HAM/WAR US 22  
16.04/0.00 PED  
HAMILTON COUNTY  
WARREN COUNTY

REVIEW COMPLETE

PROJECT DESCRIPTION

RELOCATING EXISTING PED HEADS AND PUSH BUTTONS ONTO PEDESTALS FOR BETTER ACCESSIBILITY, ADDING SIDEWALK AND CURB RAMPS TO MAKE CROSSINGS ADA COMPLIANT. INCLUDES PEDESTALS AND ASSOCIATED CONDUIT, WIRING AND PULLBOXES ALONG US-22 IN HAMILTON AND WARREN COUNTIES

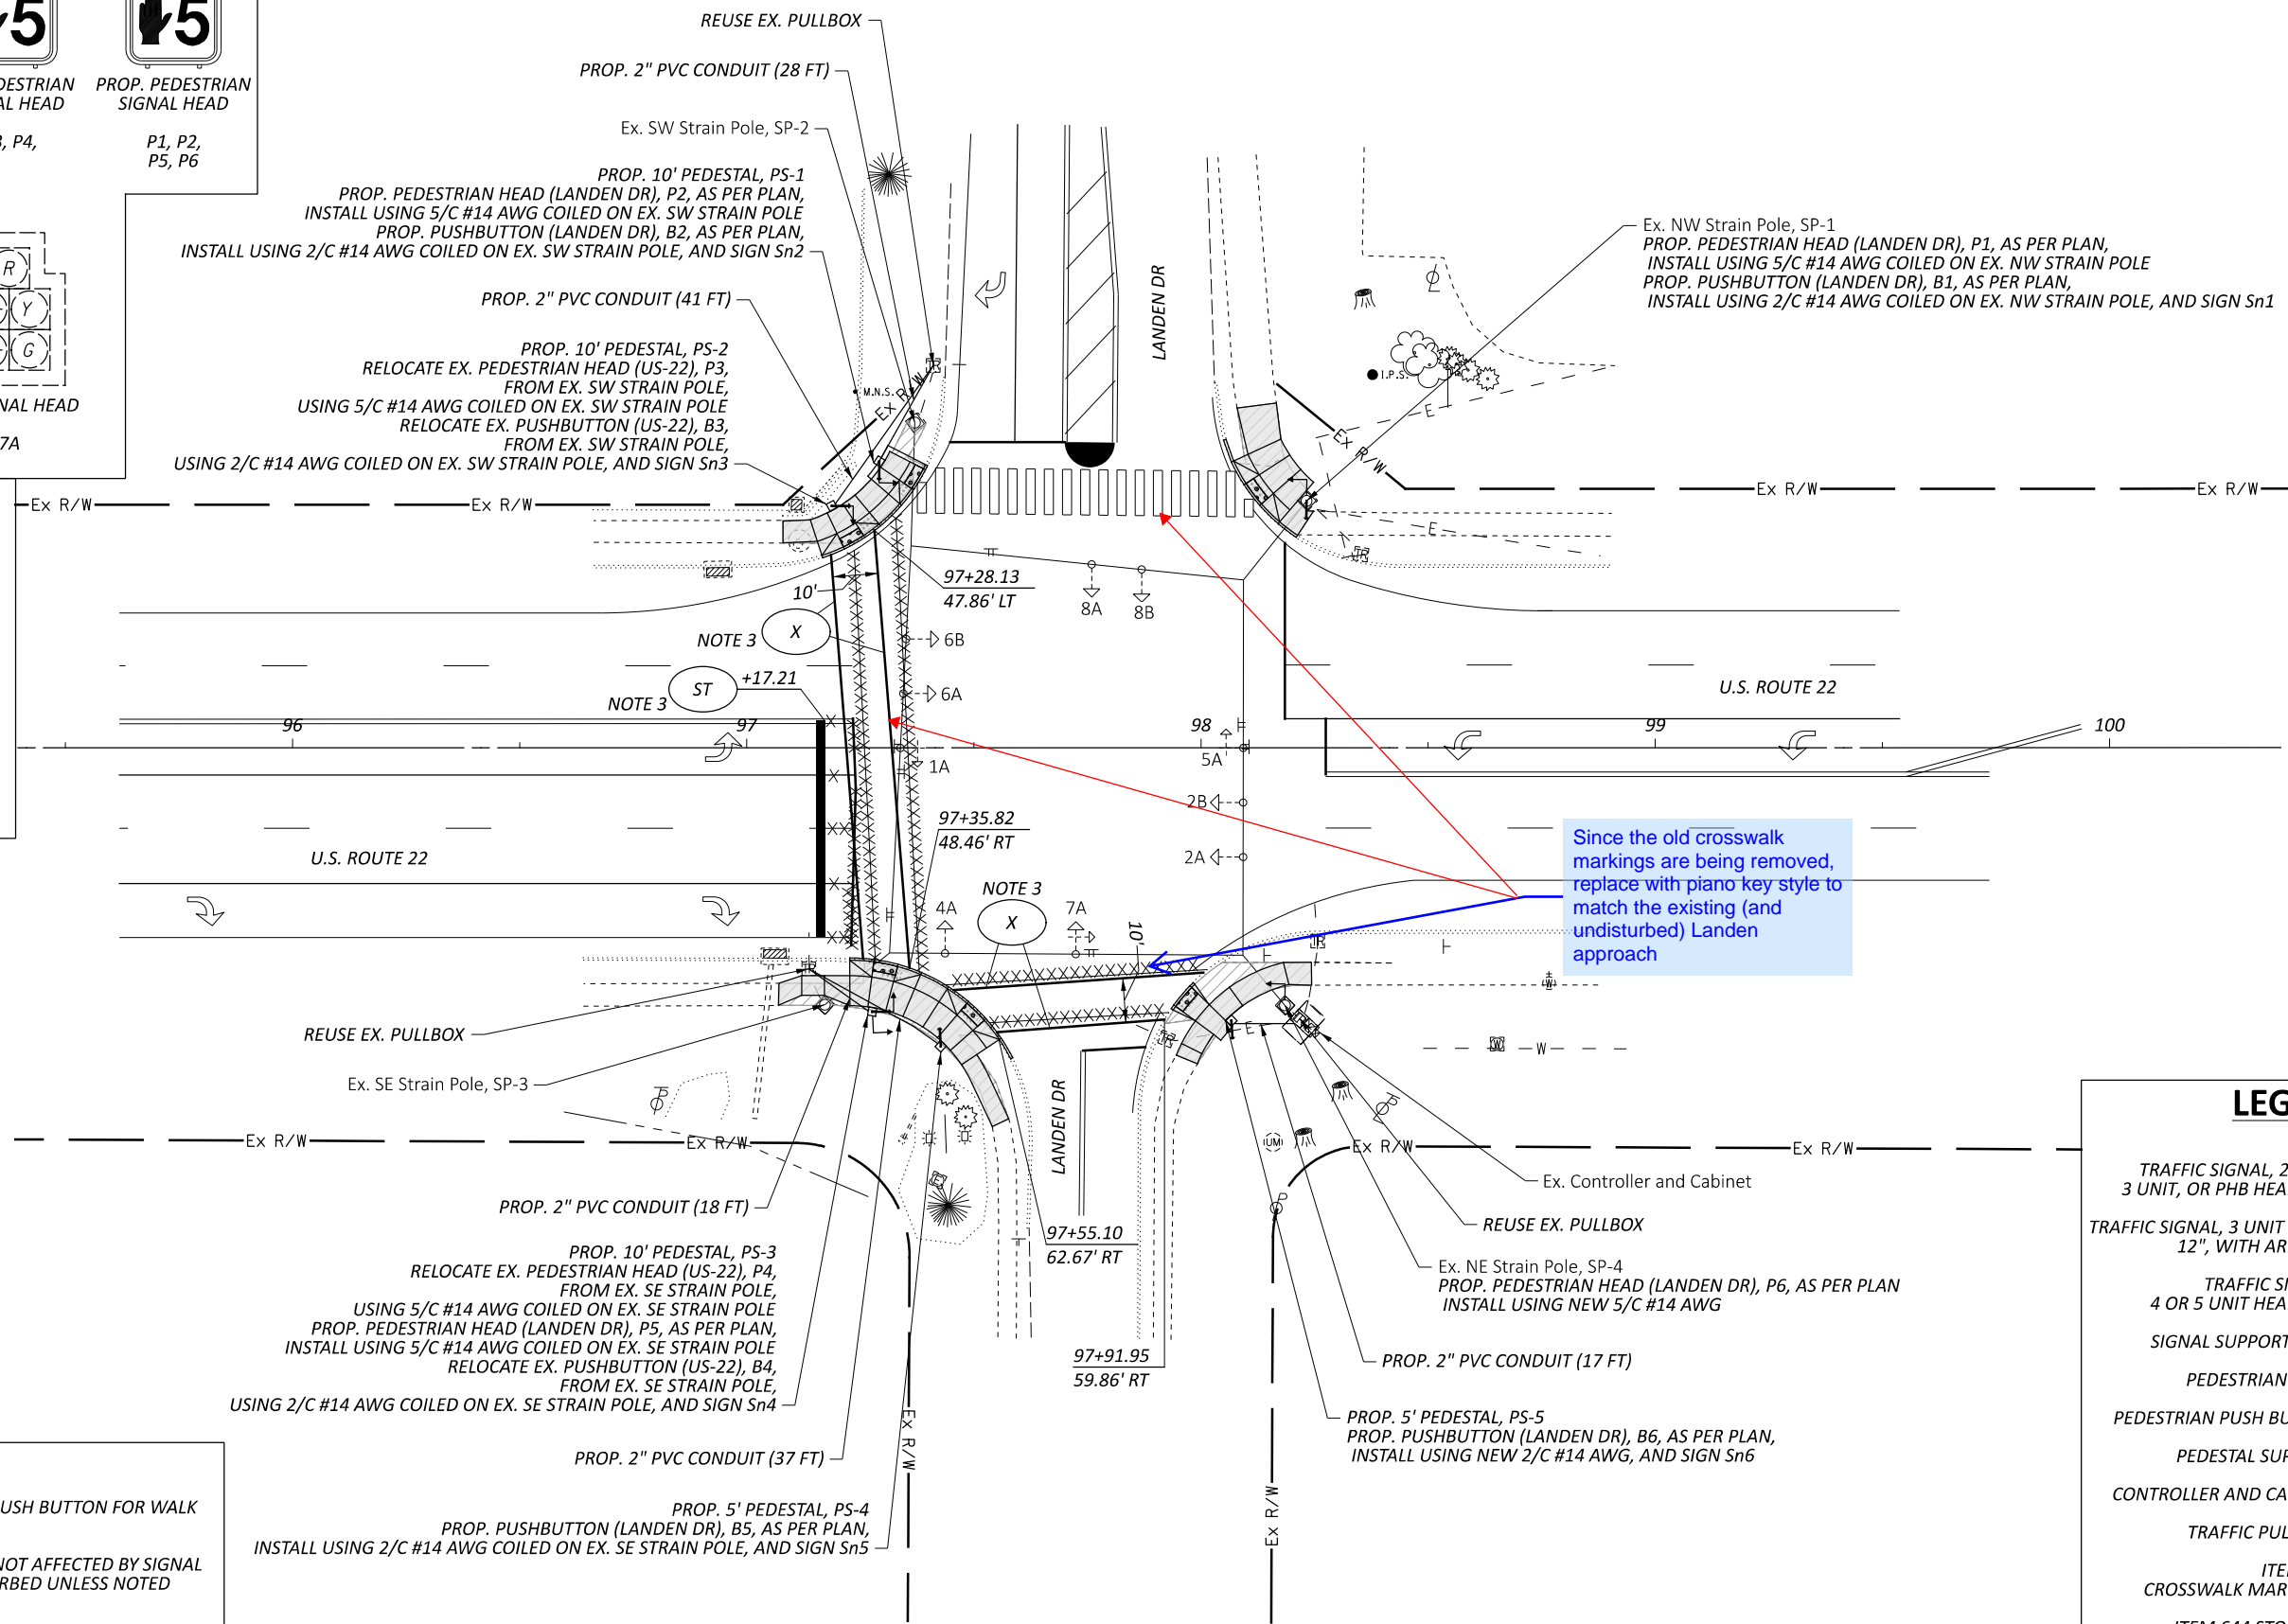
Since the old crosswalk markings are being removed, replace with piano key style to match the existing (and undisturbed) Landen approach
